Technical Service Bulletin: tsb100132

Released Date: 27-Sep-2001

Lubricating Oil Pump Sourcing Change

Fig. 1, Old K19 Lubricating Oil Pump Front Face, Part Number 3047549

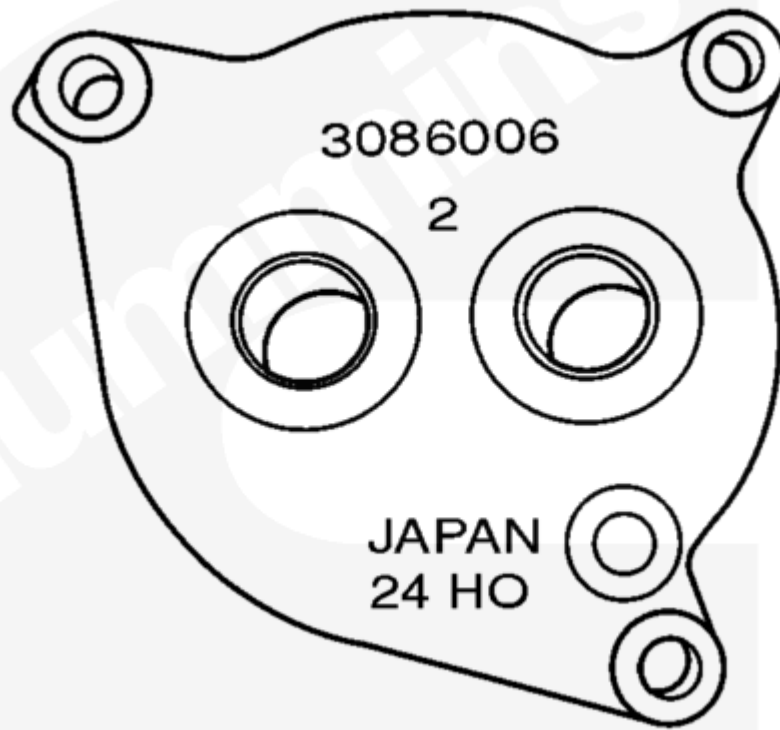
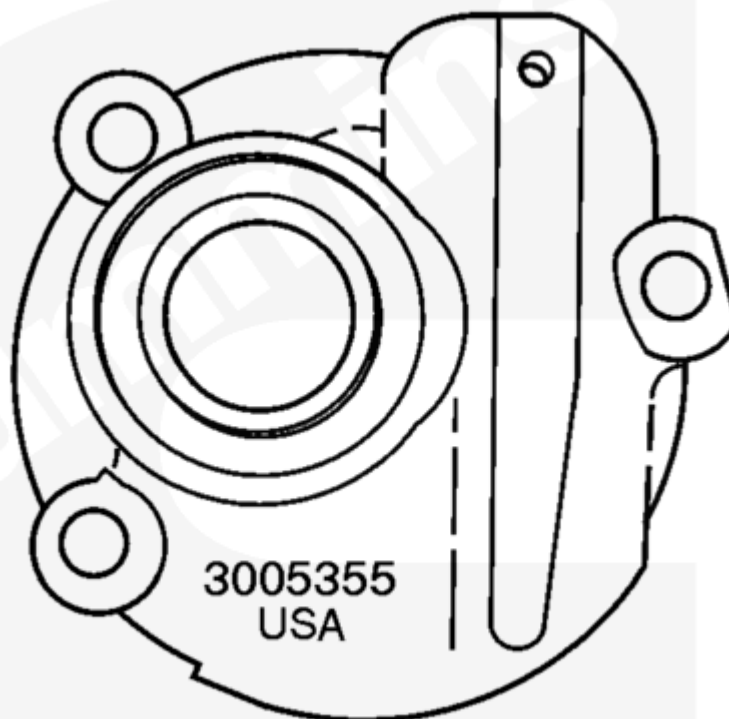
During April, May, and June 2001, a limited production of 19-liter engines was built with newly sourced lubricating oil pumps. Part Number 3047549 is used on K19 engines, and Part Number 3096326 is used on QSK19 engines. The new lubricating oil pumps have the same part numbers as the old pumps but can be identified from the casting and identification marks shown in Figs. 1 through 4.

Fig. 5, K19 Lubricating Oil Pump with Date Code AD06

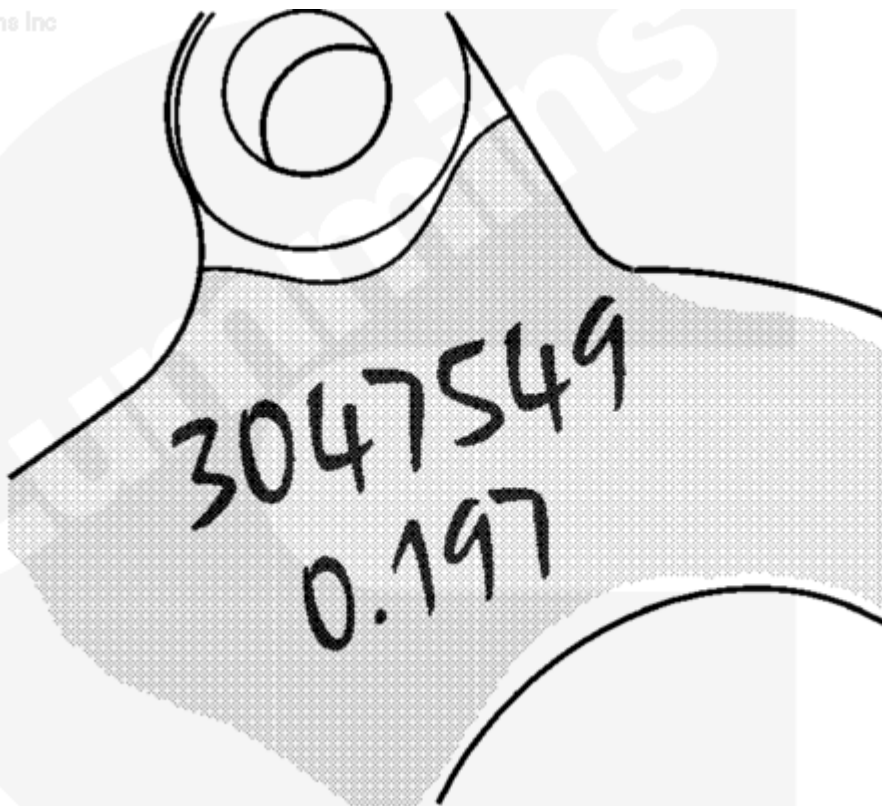
In addition to the physical appearance differences mentioned above, the new supplier will mark a colored dykem on the front face of each pump with the assembly number and measured end clearance inscribed within. The end clearance is given in millimeters. The end clearance for the QSK19 can range from 0.025 to 0.229 mm [0.001 to 0.009 in]. The end clearance for K19 can range from 0.127 to 0.254 mm [0.005 to 0.010 in]. The pump assembly date code is stamped in white outside the dykem area.

New K19 lubricating oil pumps will have an orange dykem in the locations shown in Fig. 5 and Fig. 6. The date code is stamped in white in Fig. 5.

Fig. 7, QSK19 Lubricating Oil Pump with Yellow Dykem Mark, Part Number, End Clearance, and Date Code Stamped in White

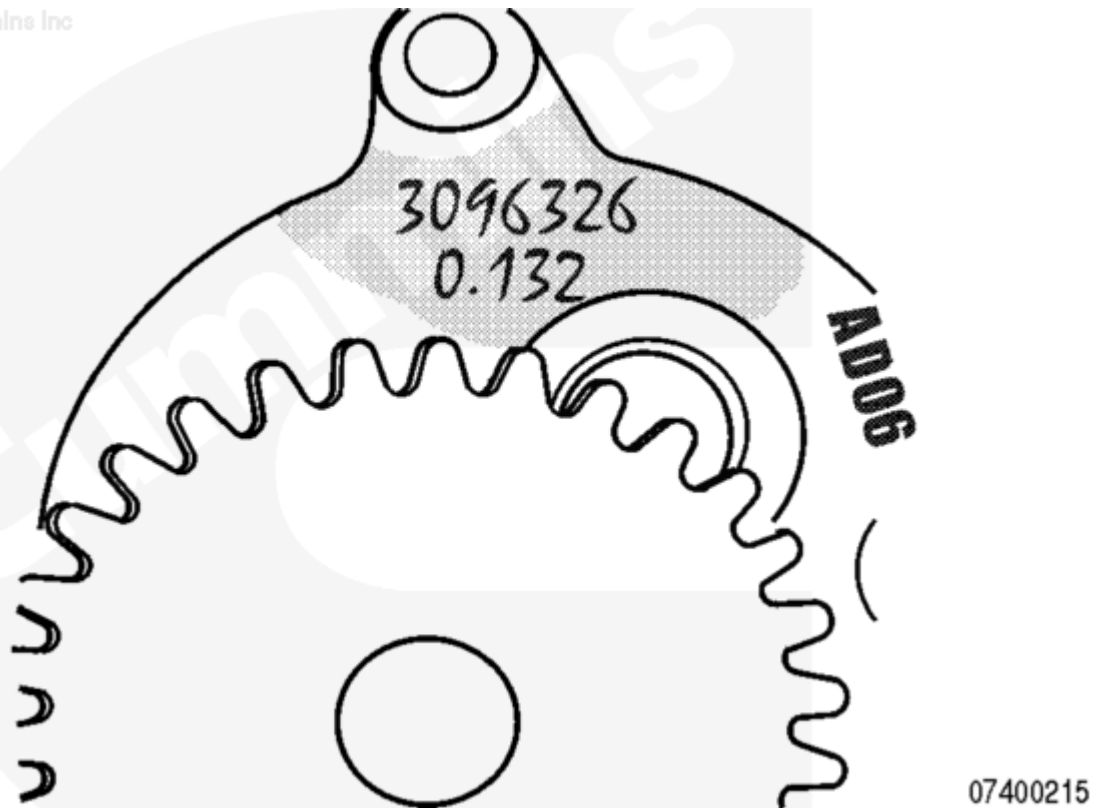
New QSK19 lubricating oil pumps will have a yellow dykem mark with the date code stamped in white.
